DESIGN RF	DRAWN BY RF	DART AEROSPACE LTD HAWKESBURY, ONTARIO, CANADA	
CHECKED <i>[Signature]</i>	APPROVED <i>[Signature]</i>	DRAWING NO. DSI 9314	REV. A SHEET 1 OF 3
DATE 05.11.11		TITLE BRACKET MODIFICATION KIT	SCALE NTS
A	05.11.11	NEW ISSUE

## DART SERVICE INSTRUCTION

TO AMEND IIN-D412-694 REV. B

REF. CANADIAN STC: SH05-10

FIGURE 1

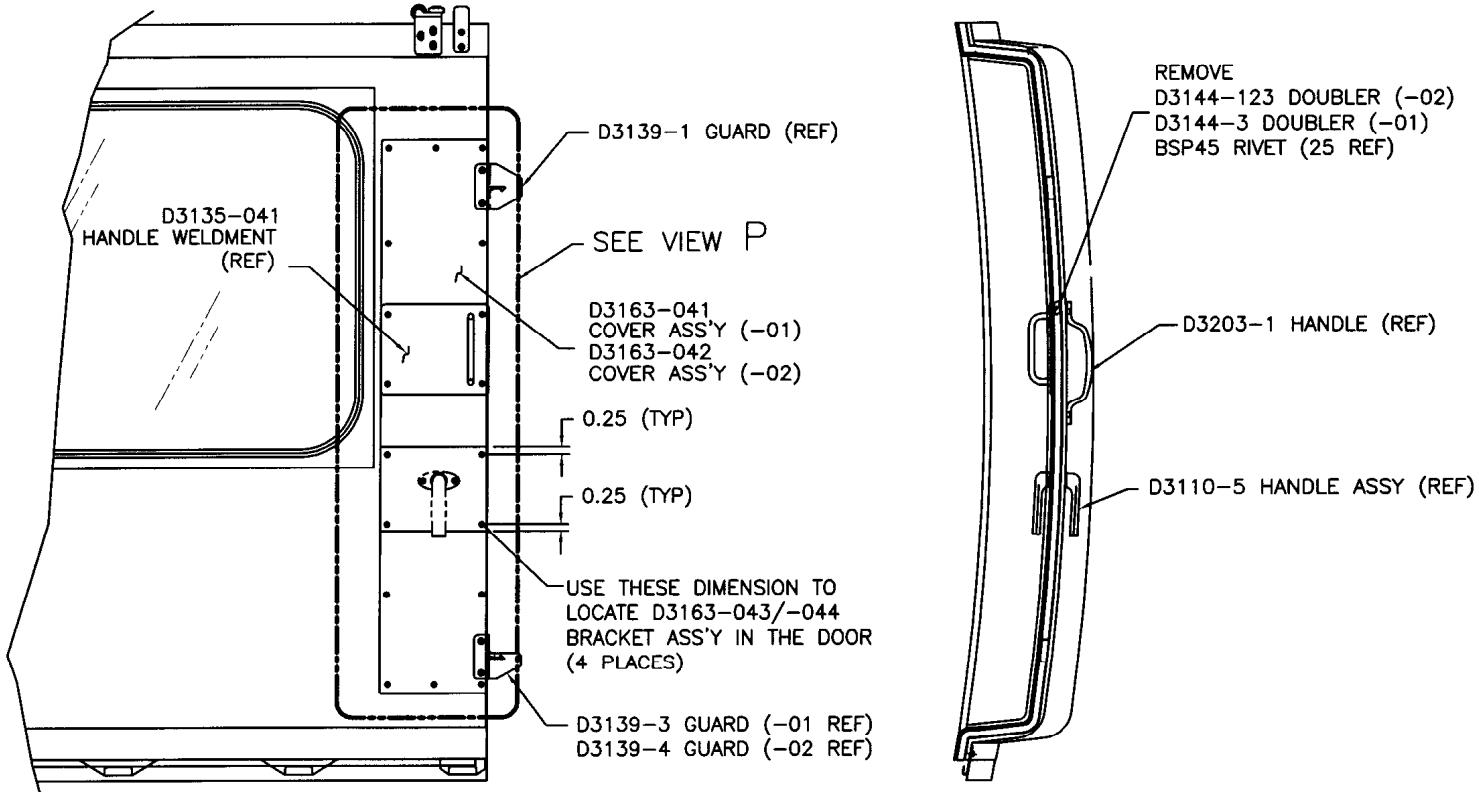
For the D412-694-01/-02 Door Assembly, if the travel of the D3110-5 Handle Assembly interferes with the D3133-041/-042 Rod Weldment or nutplate on the D3162-041 Bracket Assembly, it is acceptable to install the DSI 9314-011 Kit to correct this problem. The DSI 9314-011 Kit may be installed on D412-694-01/-02 Door Assemblies at CHG003 or earlier change numbers. This modification should be performed per the procedure below and figures 1 & 2 of this document.

- 2) Remove D3162-041 Bracket Assembly in 4 places as shown in Figure 1.
- 3) Transfer holes from the existing D3163-041/-042 Cover Assembly to the replacement cover assembly except do not transfer the 4 holes used to secure the D3162-041 Bracket in step 2 of this service instruction.

- 4) Locate holes in D3163-041/-042 as shown in Figure 2 to help properly locate D3162-043/-044 as shown in Figure 1. Transfer drill the 2 existing #30 diameter holes (used to fasten the removed D3162-041) from the door to each D3162-043/-044 Bracket Ass'y as shown in Figure 1. Touch up with Alodine per MIL-C-5541 and match original finish.

- 5) Install D3162-043/-044 Bracket Assembly as shown in Figure 1. If necessary fill any holes remaining that would be visible from the exterior of the door with Hysol EA934NA or equivalent. Touch up with Grey Primer 1144-S or equivalent and match original finish.
